## Device Errata

MPC850CE/D  
Rev. 3, 2/2003

MPC850 Device Errata  
Reference

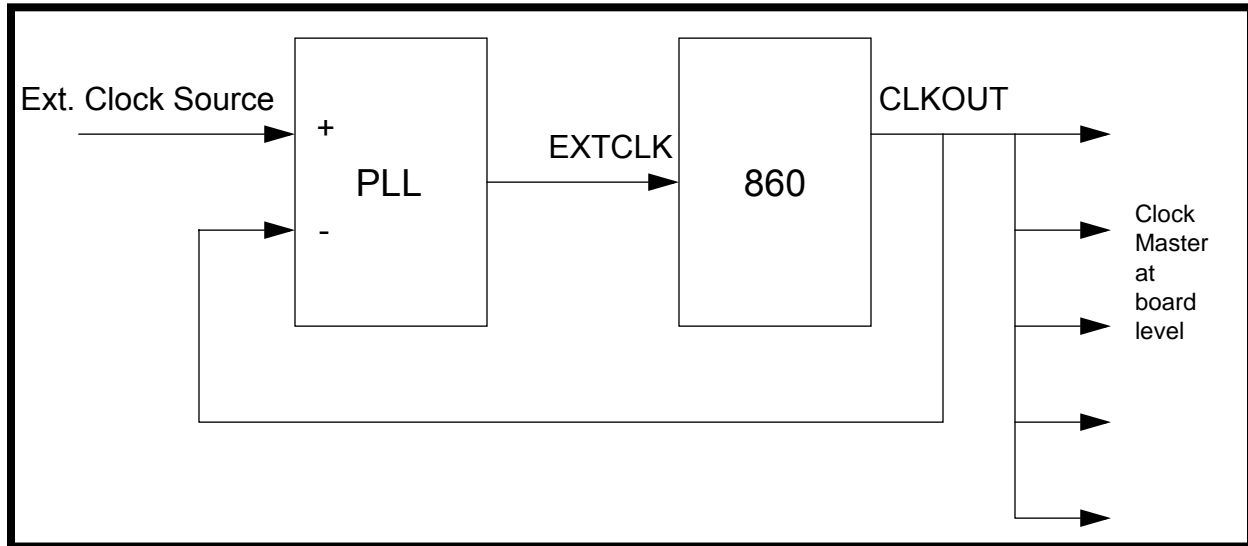
In correct operation, the PLL of the MPC850 will lock on the rising edge of the input clock. However, on these revisions of the MPC850, the PLL may lock on the falling edge of the input clock. This will affect the skew between EXTCLK and CLKOUT at the rising edge. The skew is dependent on the duty cycle of the input clock (but for a 50% duty cycle will not exceed 2nS). This will affect synchronous designs where the same clock source is used as an input to EXTCLK, as well as to an external synchronous device (e.g. a peripheral or ASIC).

Important Note: The PLL has to be capable of operating with a permanent offset of -2nS, therefore the range of lock should extend to about -4nS.

Workaround: Add external logic to delay the differential input so that the skew will be less than +8 or -20 ns.
